Product/Process Change Notice (PCN)	
<input type="checkbox"/> Major Change <input checked="" type="checkbox"/> Minor Change	
<p>PCN Number: PCN_FLYTI MID_20250306</p> <p>Affected Series: WE-FLYTI</p> <p>Affected Part Number: 750318704</p> <p>PCN Date: 2024-12-13 (YYYY-MM-DD)</p> <p>Effective Date: 2025-03-14 (YYYY-MM-DD)</p>	<p>Change Category:</p> <input type="checkbox"/> Equipment/Location <input checked="" type="checkbox"/> General Data <input type="checkbox"/> Material <input type="checkbox"/> Process <input type="checkbox"/> Product Design <input type="checkbox"/> Shipping/Packaging <input type="checkbox"/> Supplier <input type="checkbox"/> Software
<p>Contact: Product Management</p> <p>Phone: +49 (0) 7942 - 945 5001</p> <p>Fax: +49 (0) 7942 - 945 5179</p> <p>E-Mail: pcn.eisos@we-online.com</p>	<p>Datasheet Change:</p> <input checked="" type="checkbox"/> Yes <input type="checkbox"/> No <p>Attachment:</p> <input type="checkbox"/> Yes <input checked="" type="checkbox"/> No

<p>DESCRIPTION OF CHANGE:</p> <p>Because of a database mismatch, Würth Elektronik eiSos will correct the product marking in the datasheet. This is a datasheet correction only. There will be no change in form,

DETAILS OF CHANGE:	
Marking	
Before Change	After Change

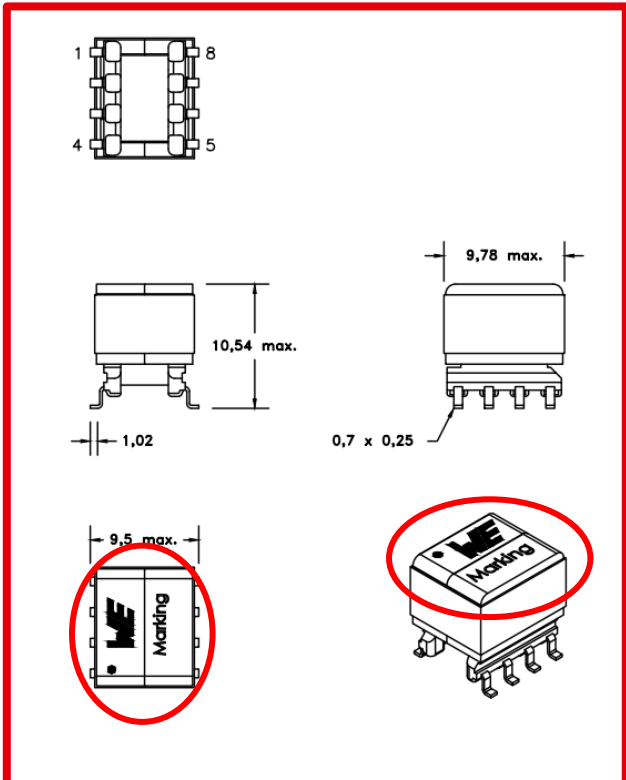
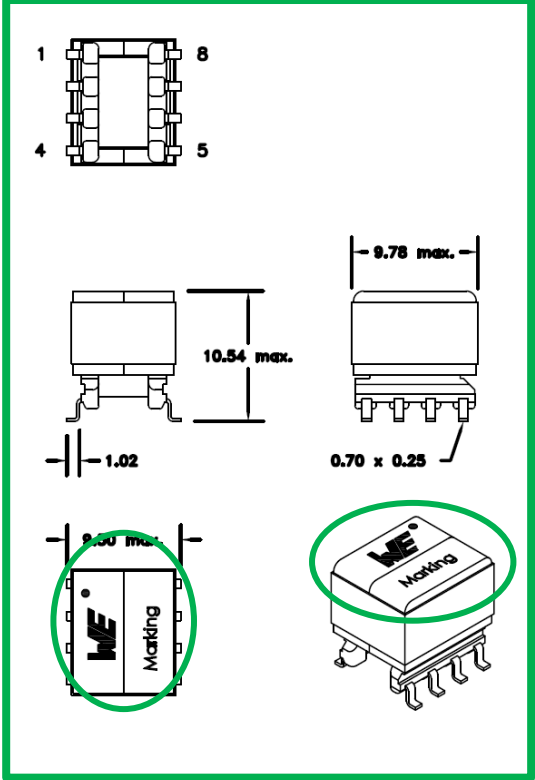
<p>Dot marking located on left side of WE marking on the top and isometric views.</p>	<p>Dot marking located on right side of WE marking on the top and isometric views.</p>

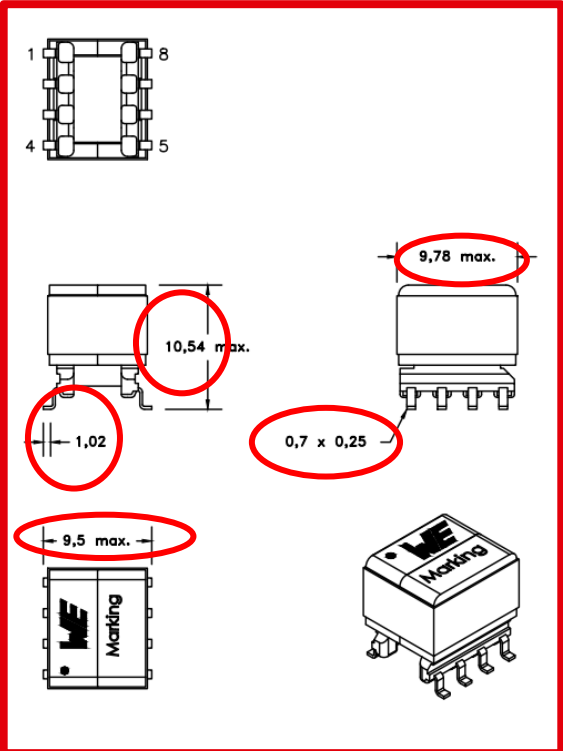
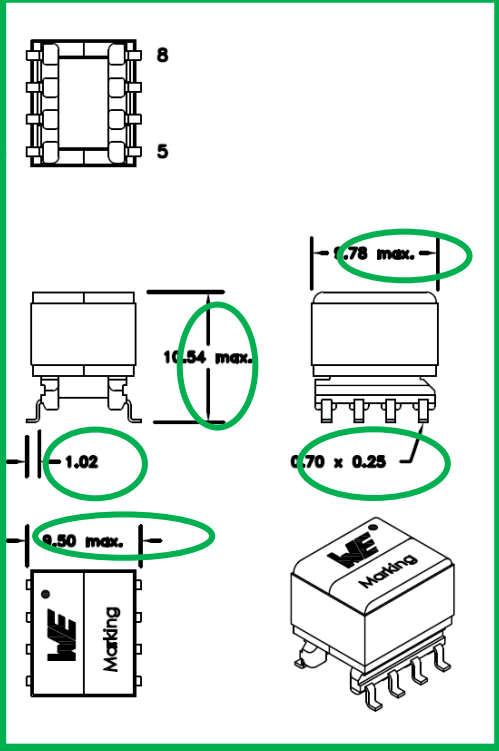
Before Change	After Change
 <p>Dimensions used commas, and 1-2 decimal places used</p>	 <p>Dimensions use period, 2 decimal places used</p>
<p>RELIABILITY / QUALIFICATION OF CHANGE:</p> <p>There will be no change of the product, therefore no additional reliability or qualification testing was performed. The new packaging was checked according to internal quality standards.</p>
